**Title:** Permit #25-141: County Road 6 Pond Retrofit

**Prepared by:** Name: Veronica Sannes, Permitting Technician  
Phone: (952) 641-4580  
Email: vsannes@minnehahacreek.org

**Recommendation:**

Approval of MCWD permit 25-141 in accordance with the submitted plans and following conditions:

Attachment C – Floodplain Figure

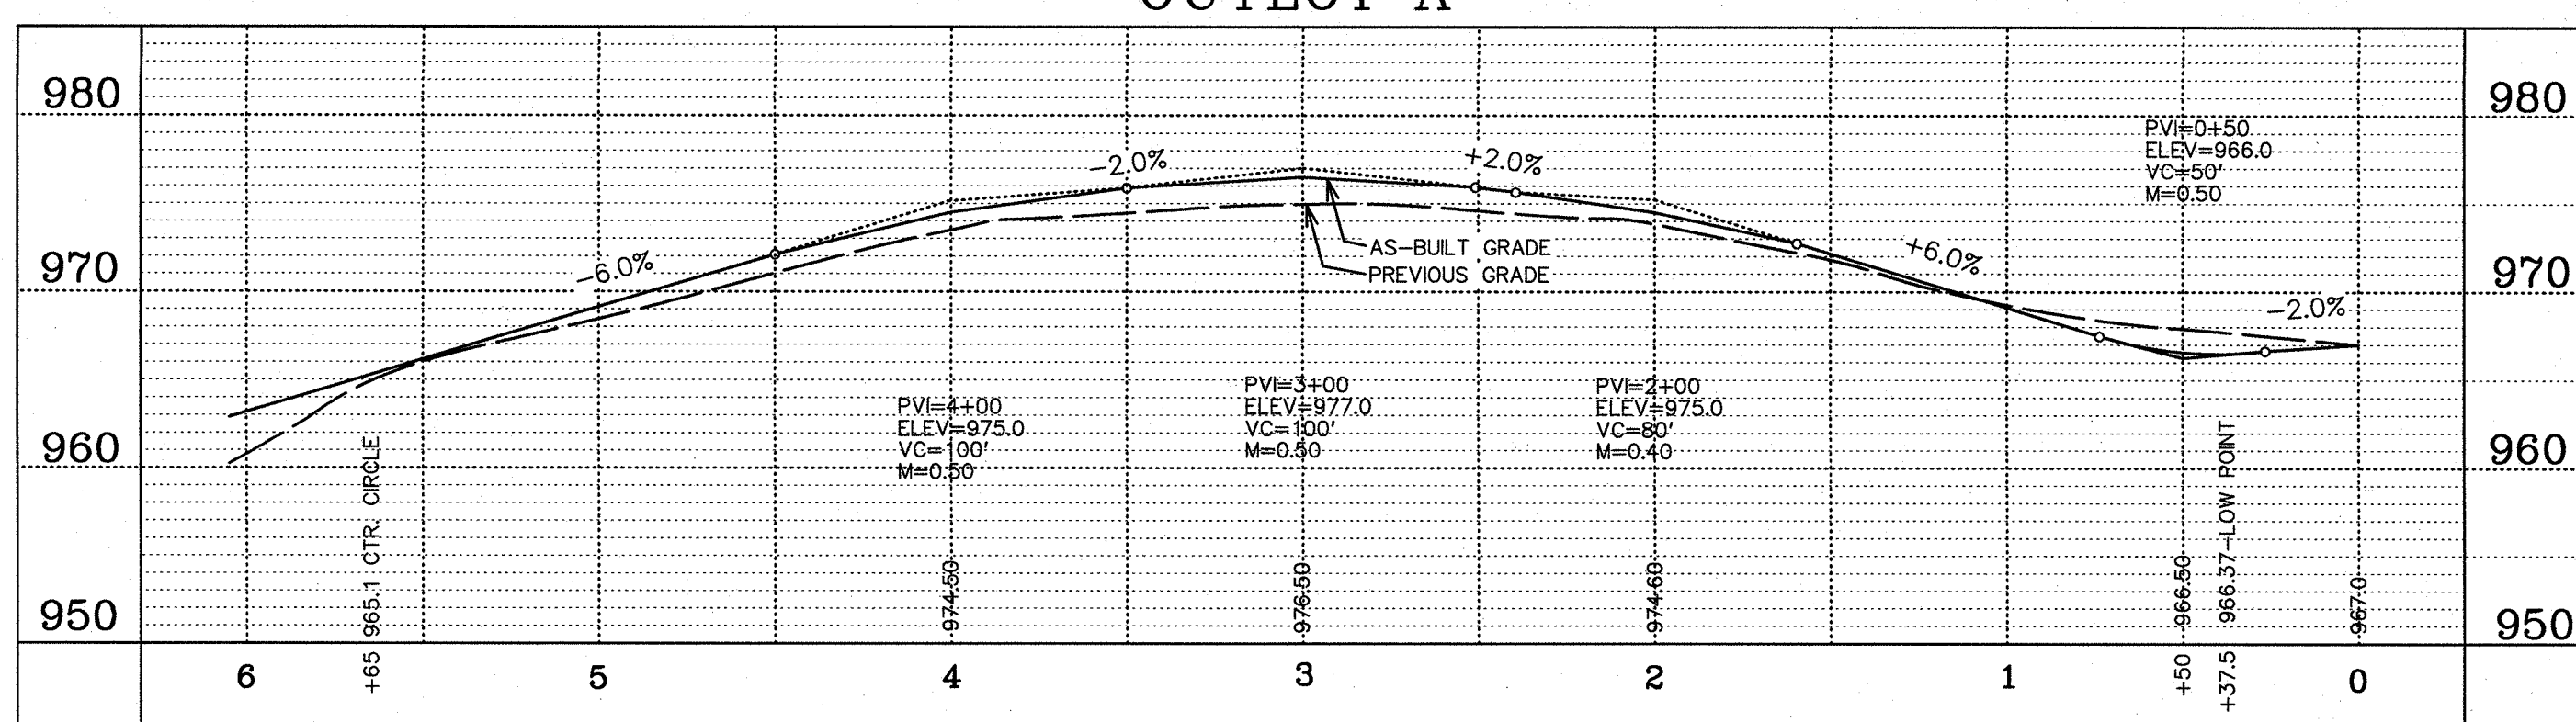
Section 4(a) states that any floodplain fill must be offset so there is no loss in flood storage between the OHW and 100-year floodplain. The Project proposes 6 cubic yards of fill within the floodplain and 140 cubic yards of excavation. This results in 134 cubic yards of net compensatory storage, therefore meeting the rule requirements. Attachment C illustrates the locations of the proposed work within the floodplain.
